EA-03-009

**SUBJECT: ISSUANCE OF FIRST REVISED NRC ORDER (EA-03-009) ESTABLISHING
INTERIM INSPECTION REQUIREMENTS FOR REACTOR PRESSURE
VESSEL HEADS AT PRESSURIZED WATER REACTORS**

FIRST REVISED ORDER MODIFYING LICENSES

Figure IV-1: Inspection Area Using Ultrasonic Inspection Technique Without Stress Analysis
(Nozzle area in black to be volumetrically inspected.)

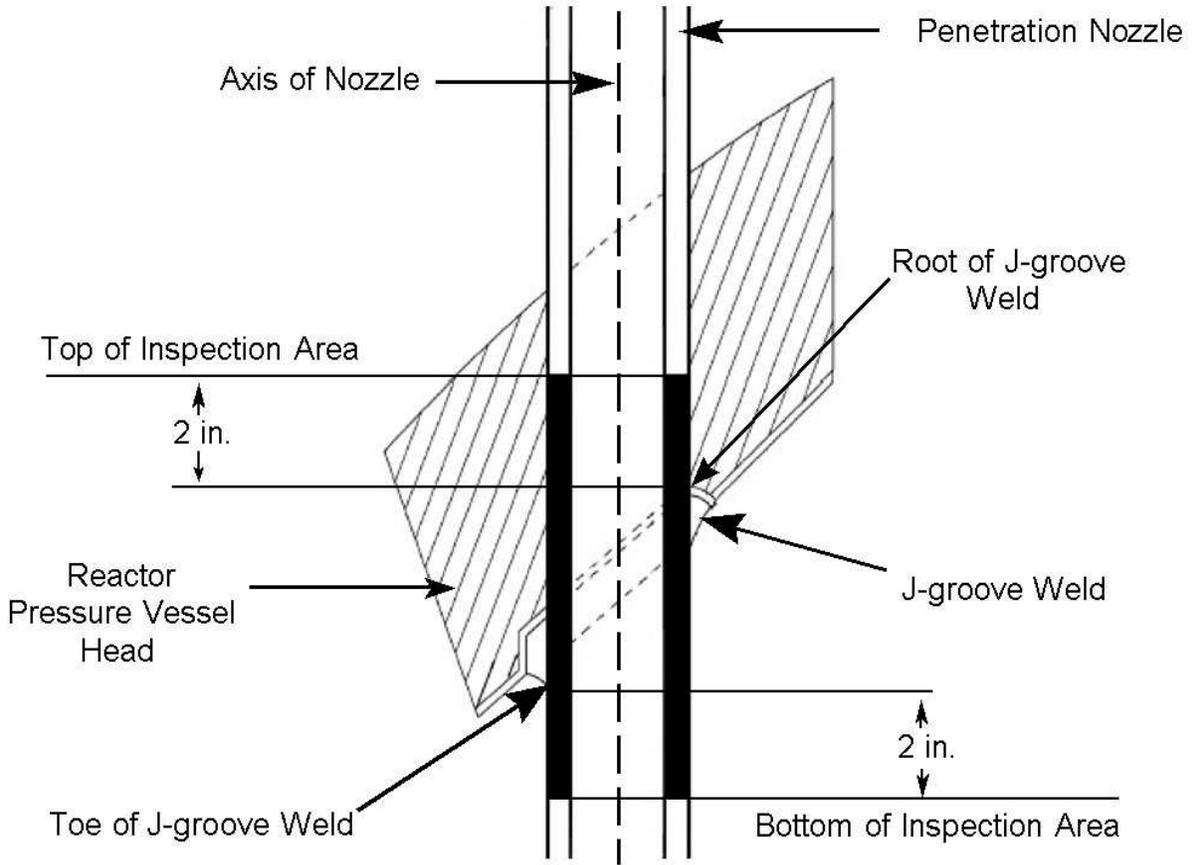
- (i) Ultrasonic testing of the RPV head penetration nozzle volume (i.e., nozzle base material) from 2 inches above the highest point of the root of the J-groove weld (on a horizontal plane perpendicular to the nozzle axis) to 2 inches below the lowest point at the toe of the J-groove weld on a horizontal plane perpendicular to the nozzle axis (or the bottom of the nozzle if less than 2 inches [see Figure IV-1]); OR from 2 inches above the highest point of the root of the J-groove weld (on a horizontal plane perpendicular to the nozzle axis) to 1.0-inch below the lowest point at the toe of the J-groove weld (on a horizontal plane perpendicular to the nozzle axis) and including all RPV head penetration nozzle surfaces below the J-groove weld that have an operating stress level (including all residual and normal operation stresses) of 20 ksi tension and greater (see Figure IV-2). In addition, an assessment shall be made to determine if leakage has occurred into the annulus between the RPV head penetration nozzle and the RPV head low-alloy steel.

Figure IV-3: Required Wetted Surface Inspection Area Without Stress Analysis (The penetration nozzle and J-groove weld surface areas in black require surface inspection.)

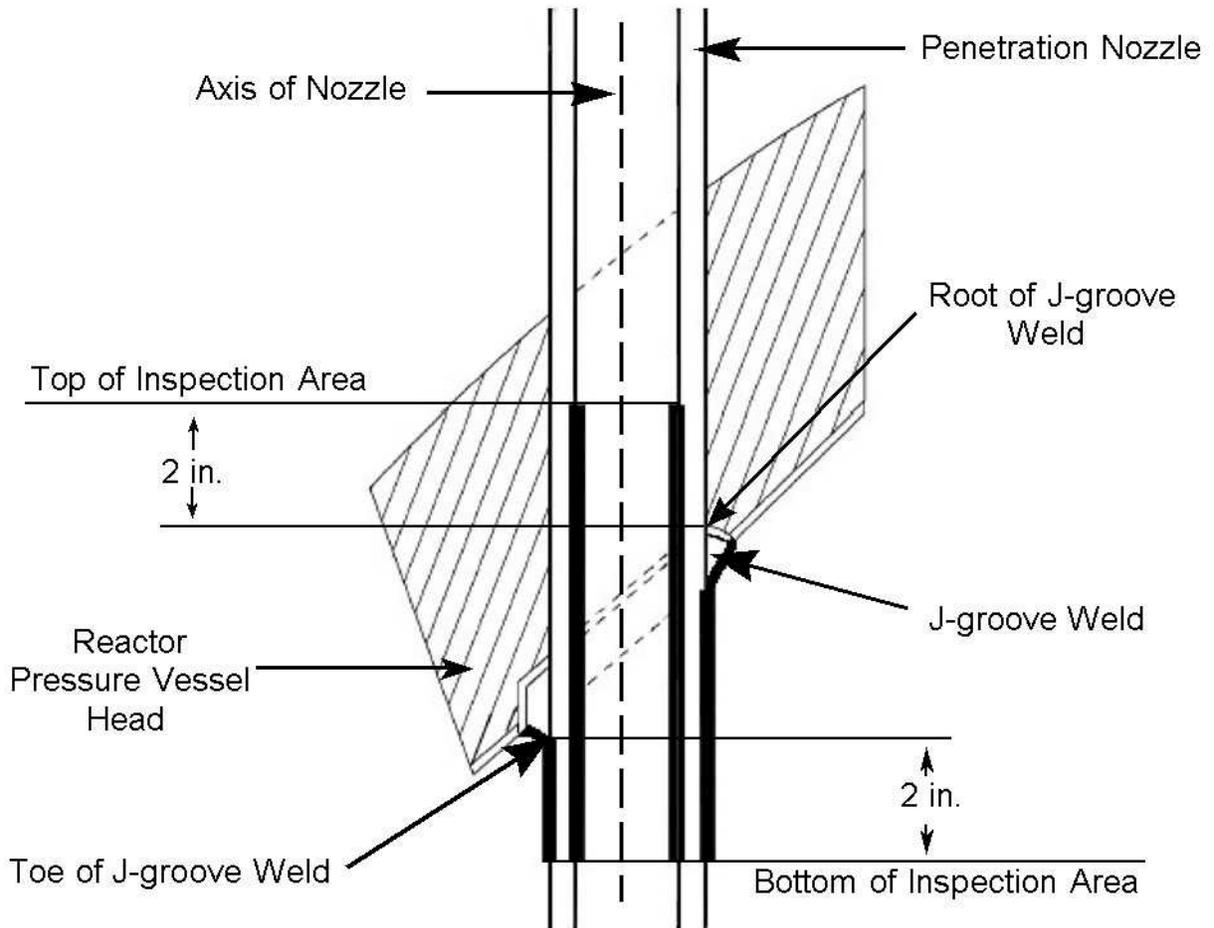
- (ii) Eddy current testing or dye penetrant testing of the entire wetted surface of the J-groove weld and the wetted surface of the RPV head penetration nozzle base material from at least 2 inches above the highest point of the root of the J-groove weld (on a horizontal plane perpendicular to the nozzle axis) to 2 inches below the lowest point at the toe of the J-groove weld on a horizontal plane perpendicular to the nozzle axis (or the bottom of the nozzle if less than 2 inches [see Figure IV-3]); OR from

Figure IV-4: Required Wetted Surface Inspection Area With Stress Analysis (The penetration nozzle and J-groove weld surface areas in black require surface inspection. Nozzle area in grey requires surface inspection only if applied stress is ≥ 20 ksi in that specific area.)

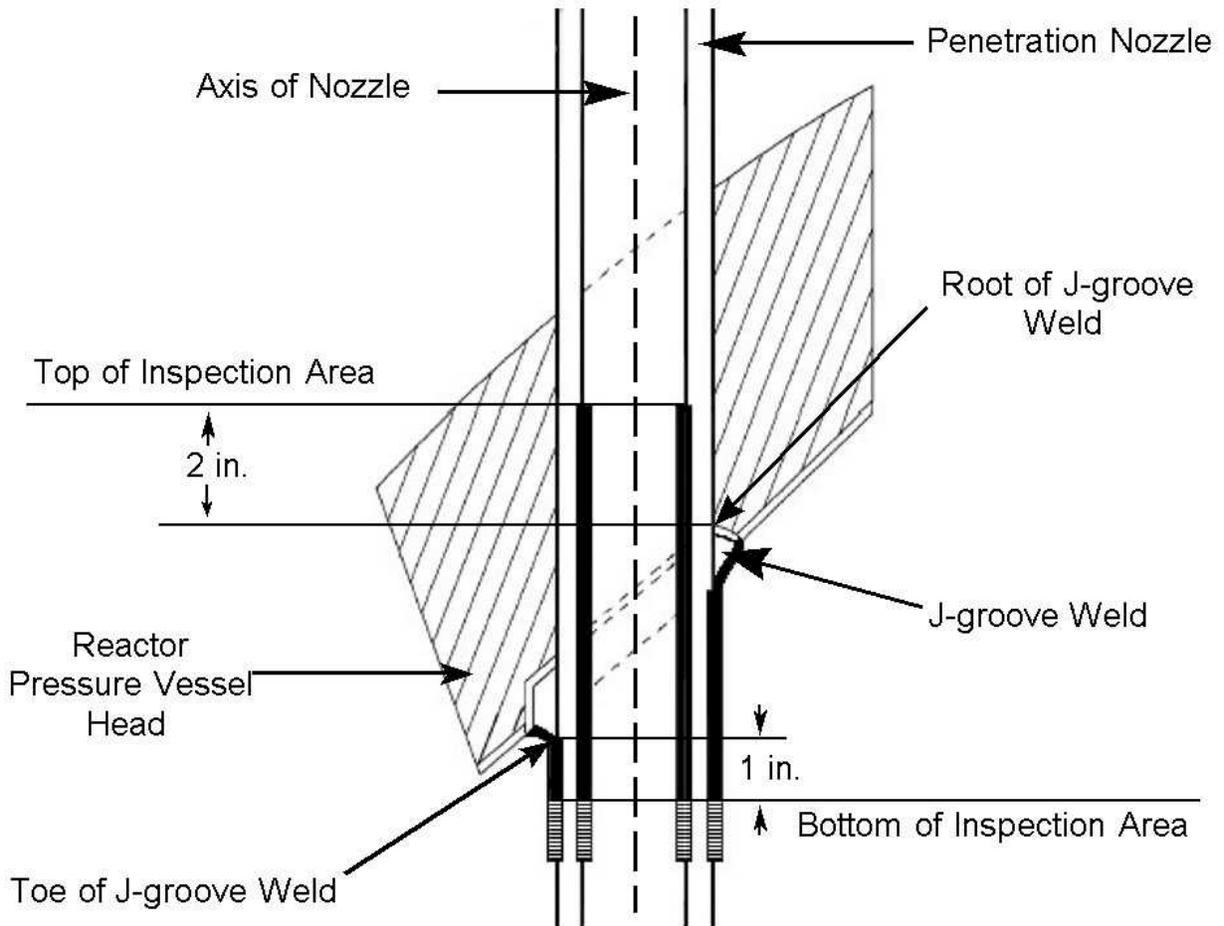
2 inches above the highest point of the root of the J-groove weld (on a horizontal plane perpendicular to the nozzle axis) to 1.0-inch below the lowest point at the toe of the J-groove weld (on a horizontal plane perpendicular to the nozzle axis) and including all RPV head penetration nozzle surfaces below the J-groove weld that have an operating stress level (including all residual and normal operation stresses) of 20 ksi tension and greater (see Figure IV-4).
